## **Uniting Aged Care Development Kingscliff**

I write in objection to Uniting Kingscliff Redevelopment SSD- 47110 5958

### **41 Drift Court**

**Image 1**

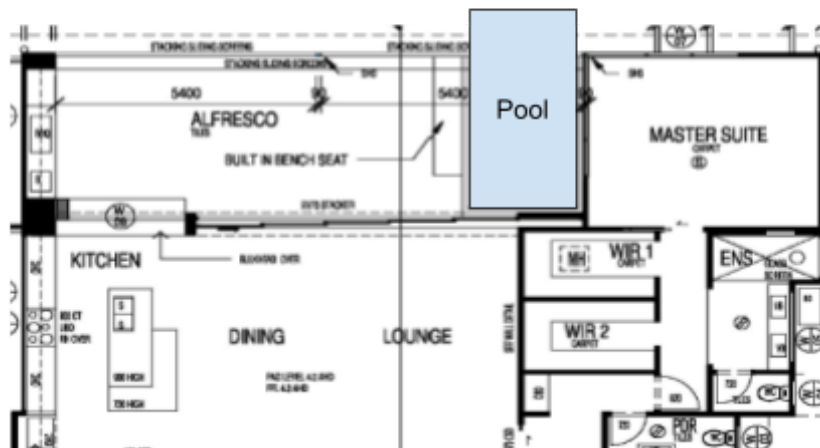
**Image 1** below shows the ground floor plan for 41 Drift Court and the position of Building F. The alfresco, pool and master bedroom face north. The proposed Building F building has many windows and balconies that will look directly into our alfresco, pool and master bedroom.

**Image 2**

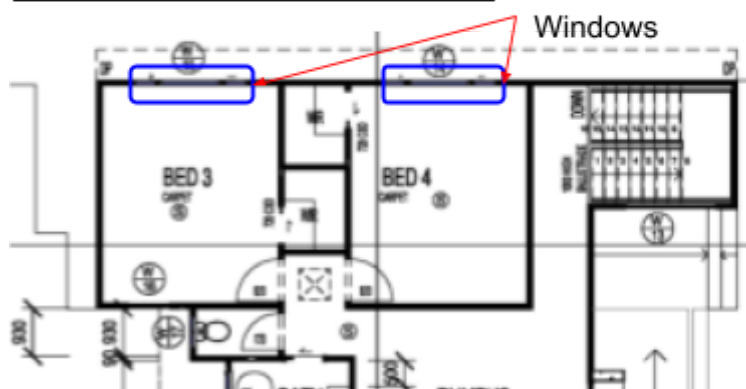
**Image 2** below shows plan for the second floor for 41 Drift Court and the position of Building F. Our two daughter's bedrooms face north. The proposed Building F building has many windows and balconies that will look directly into these two bedrooms.

**Image 3 - rear view of Building F**

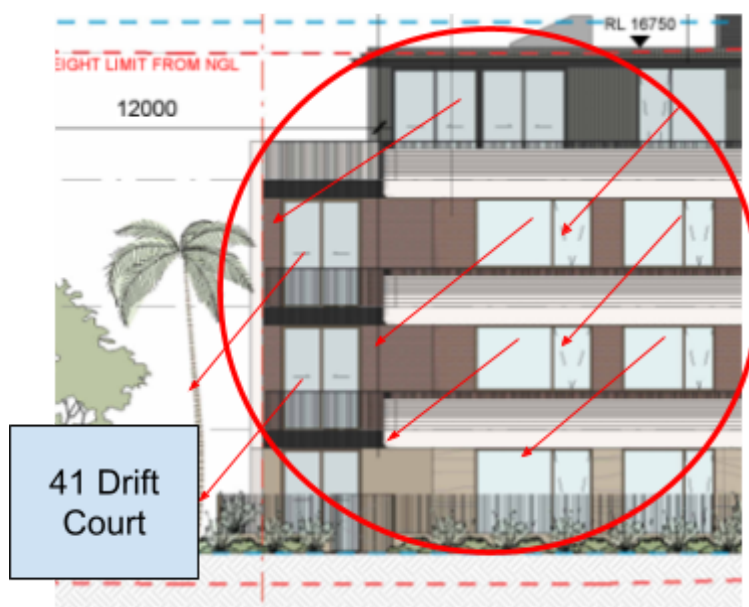
**Images 3 and 4** below show the proposed Building F (back of the building and the side of the building) in relation to 41 Drift Court. There are more than 50 windows and 30 balconies (Building F and Building E) that will look directly into the alfresco area, pool, master bedroom and the two second level bedrooms. The top floor balcony has planter boxes for privacy which will not provide adequate privacy to our house. During the consultation process I requested a cross section diagram showing sightlines from Building F into our ground floor and second floor. I was promised this would be sent, however it was never received.

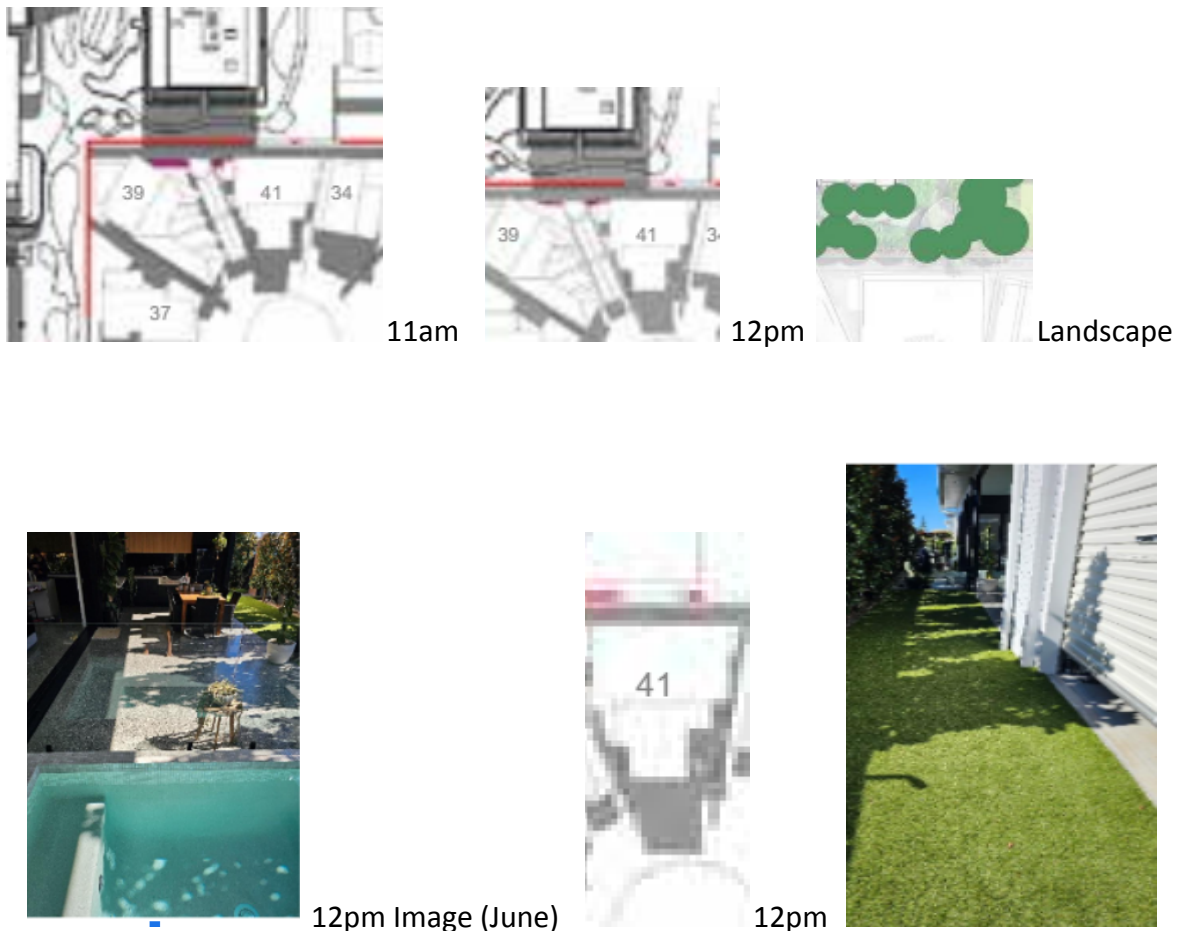
The images below are an example of the shadow diagrams from the Architectural Design Report. It is difficult to see the true effect of shadowing on our dwelling due to the scale of the images. I request a more detailed shadow diagram that shows the shadowing impacts of Building F on our private open space and living area.

The above images depict our current sun levels in June, if you reference (middle image) from the architectural design report (page 49) it shows that 41 Drift Court currently receives no sun (backyard and private open space) which is very misleading and clearly not accurate.

The shadow diagrams provided are on a large scale (possibly 1:500), resulting in very minimal details for each individual dwelling. Such a scale that does not adequately demonstrate the degree of overshadowing on our property. The shadow diagrams should be scaled at 1:100, this would provide detailed information to show compliance and impact on the open space of each dwelling, including hourly shadows on each private open space, alfresco and outdoor space, as well as indoor living and north-facing windows of habitable rooms. Floor plans/elevations should accurately portray the winter sun angles that apply to our property. The shadows should also be more accurate with current conditions, heights of

topography and fences (our current back fence is 1.8m high, not 2.7m as indicated in one of the drawings).

**Image 7**

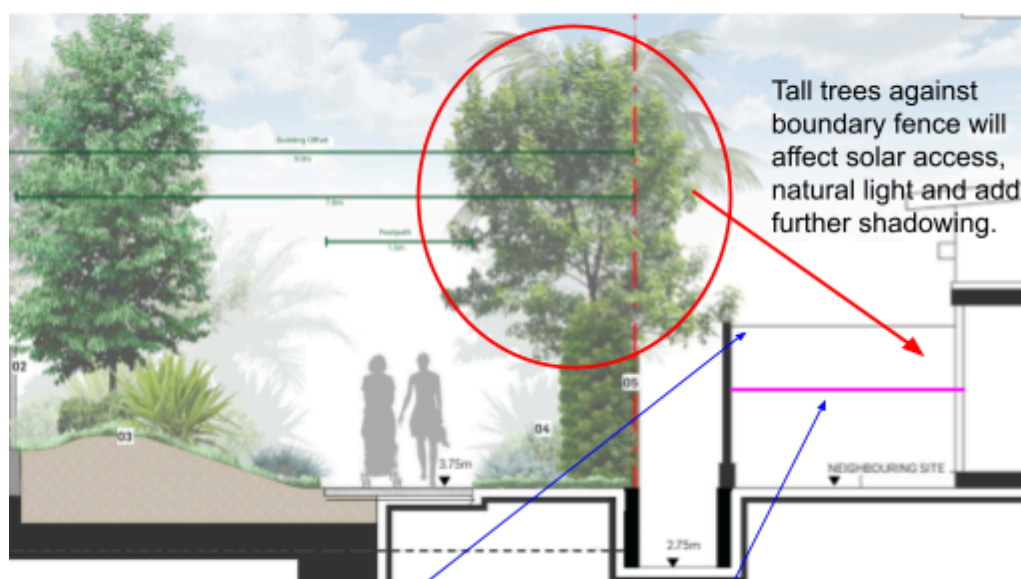
Misleading diagram showing our boundary fence (1.8m high) provides privacy to a height of approx. 2.7m (nearly to the top of our outdoor ceiling which is 3m high). The pink line above shows a more realistic height of the fence and the line of privacy.

**Image 8**

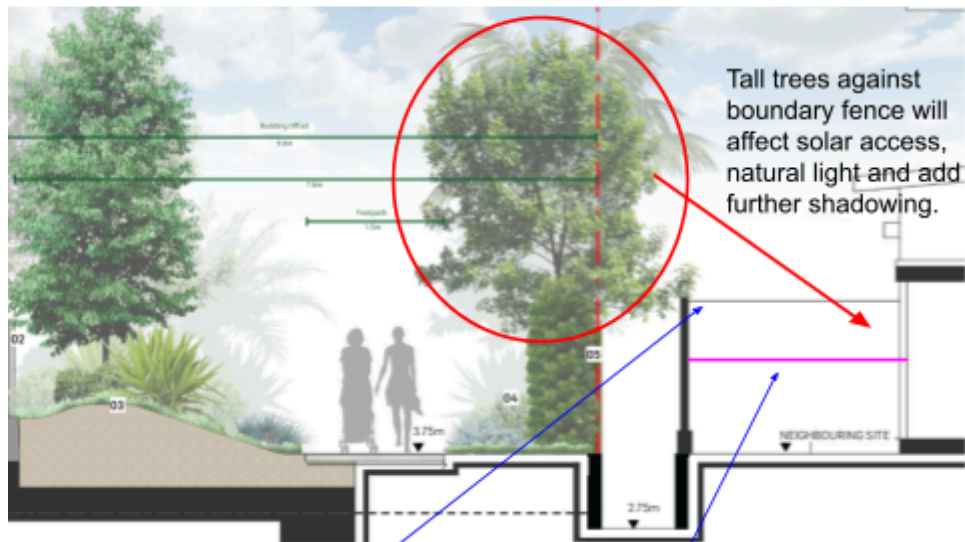
Proposed tall tree plantings will inhibit natural light from reaching lower level indoor and outdoor living.

Image 12

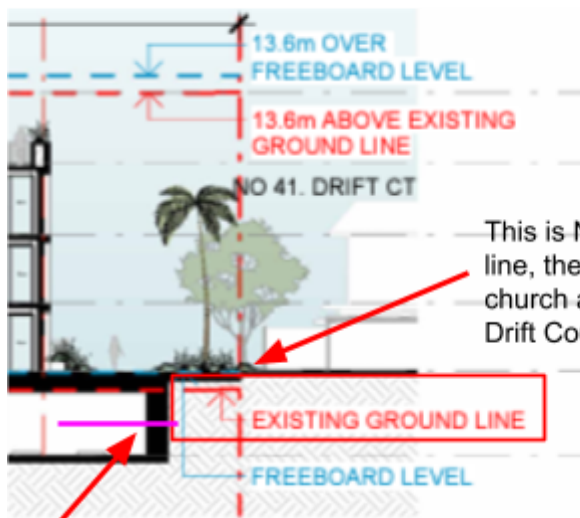
However, the plans for the proposed development depict the natural ground level for the proposed site to be at the same level as 41 Drift Court, as can be seen in the image below.

Image 13 below, contradicts image 12. Image 13 shows the existing church sitting on the same ground level as level one of Building F. However, Image 12 shows level one of Building F sitting at the same height as 41 Drift Court, which is approx 1.3m higher than the church. We seek clarification around this. If level one is going to sit on the same ground level as 41 Drift Court, we will have a large

**Image 13**

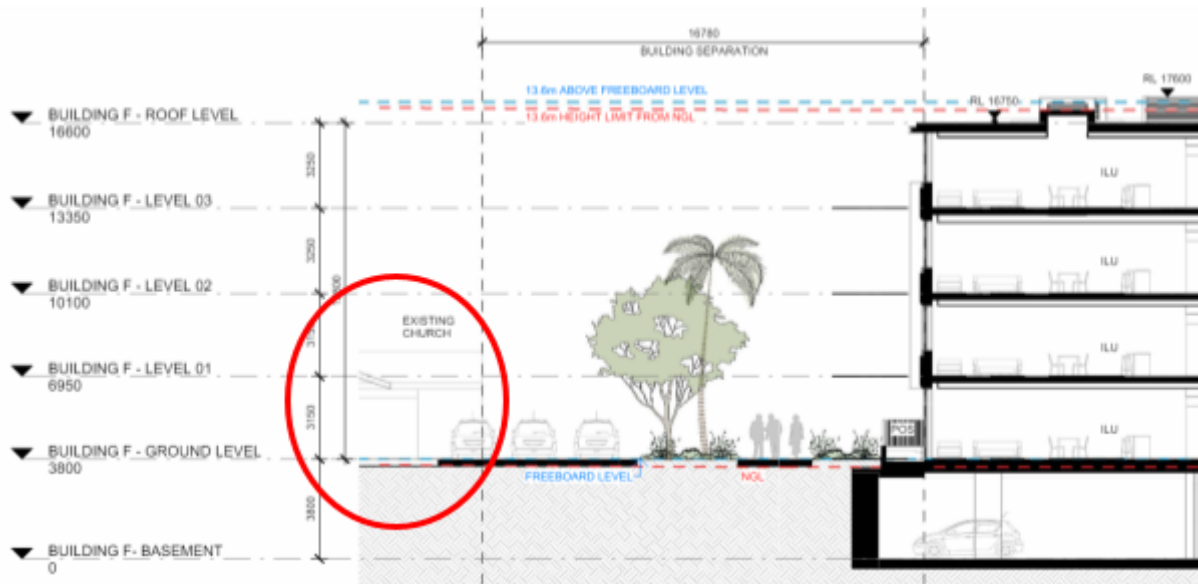
building, 2 stories higher than our house looking in on us, this is not acceptable and not within keeping with the context of the existing built environment.

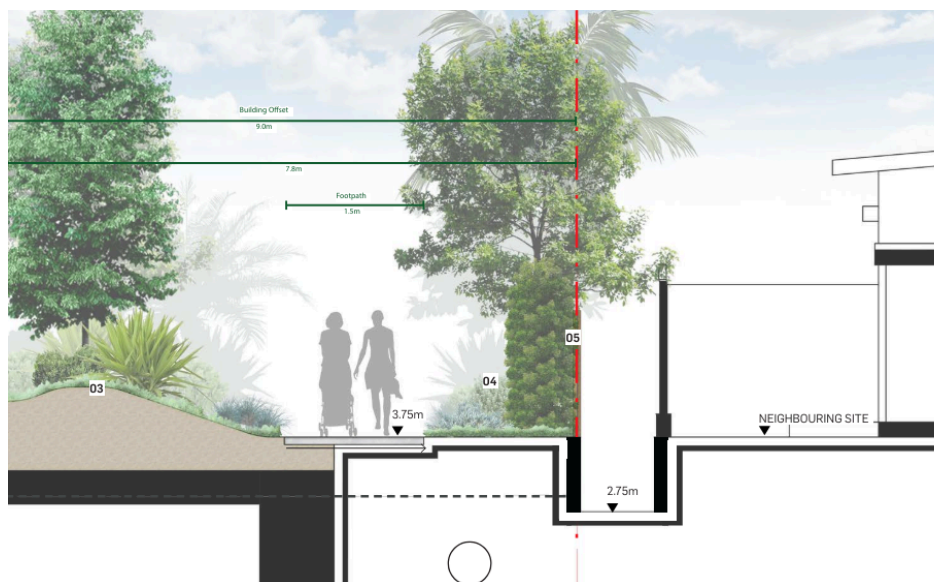
The proposed development lacks detail and consideration regarding the shadowing of surrounding properties. Below is an image illustrating how the development interacts with our property.

Trees planted on the boundary will further shadow our property. Please note, as mentioned earlier, the 60% solar loss calculation does not account for any additional plantings on our boundary. Shadowing assessments should include landscaping intent.
